SUBJECT: PALISADES NUCLEAR PLANT INTEGRATED INSPECTION REPORT  
05000255/2014002

Report No: 05000255/2014002

Facility: Palisades Nuclear Plant

Dates: January 1 through March 31, 2014

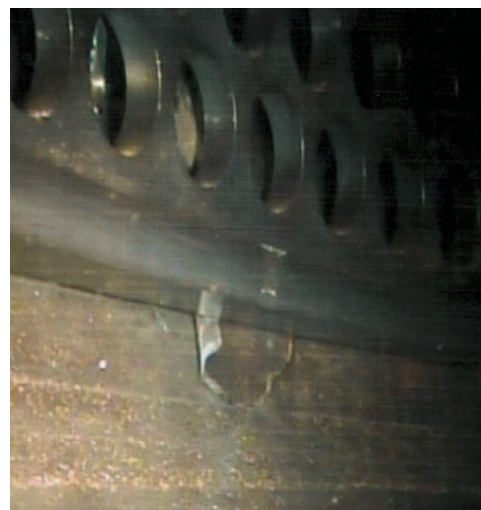
The reactor vessel is shown in the figures below. Four PCPs circulate water through the PCS. After the water has passed through the steam generators and transferred heat to the secondary system, the water is pumped by the PCPs through the PCS cold legs and into the reactor vessel. In the included figures that depict the Palisades PCS, one cold leg (inlet nozzle) and one hot leg (outlet nozzle) are shown for the purpose of simplicity. In actuality, there are four cold legs and two hot legs. Water enters the reactor vessel via the cold legs and flows down between the reactor vessel wall and the core support barrel. Near the bottom of the vessel is a flow skirt that contains many small holes that most of the water flows through. Some water also passes below the flow skirt into the bottom of the vessel. After flowing through or under the flow skirt, the water then flows up into the active fuel region to remove heat from the nuclear fuel. After flowing through the fuel region, the water exits the vessel through the hot legs and into the steam generators.

Since the licensee could not remove the impeller piece from the vessel, Operability Evaluation CR-PLP-2014-01510 was developed to evaluate the operability of the reactor vessel. The piece was tapered in thickness from  $\frac{3}{16}$  inches to roughly one inch wide,

and the gap between the vessel wall and flow skirt where the piece was wedged was up to ½ inch wide. The piece was not blocking any of the flow holes through the flow skirt. Plant history has shown that prior broken impeller pieces that passed through the gap were found at the bottom of the vessel. The licensee performed a fluid dynamics analysis to determine the forces that would act on the piece during plant operation, which concluded that the maximum force would be a 350 pound lift force. The site then performed a structural analysis to determine the effects of the piece and hydraulic forces on the reactor vessel and flow skirt. Heatup and cooldown effects were considered and the flow skirt and vessel were determined to move together such that the gap size would remain constant. A fracture analysis was performed to determine if the piece would break up into smaller pieces during the operating cycle. The analysis assumed several initiating crack sizes in the piece, all of which determined that the crack growth rate would reduce and essentially stop once the crack depth approached 75 percent of the thickness of the piece. Based on the results of the analyses, the licensee concluded that the piece would not move, would not break up, would not impede PCS flow, and would not affect the pressure-retaining capability of the reactor vessel. The analyses were performed as a joint effort between the licensee and equipment vendors. The licensee's Operability Evaluation concluded the reactor vessel was operable with the impeller piece wedged between the reactor vessel and the flow skirt.
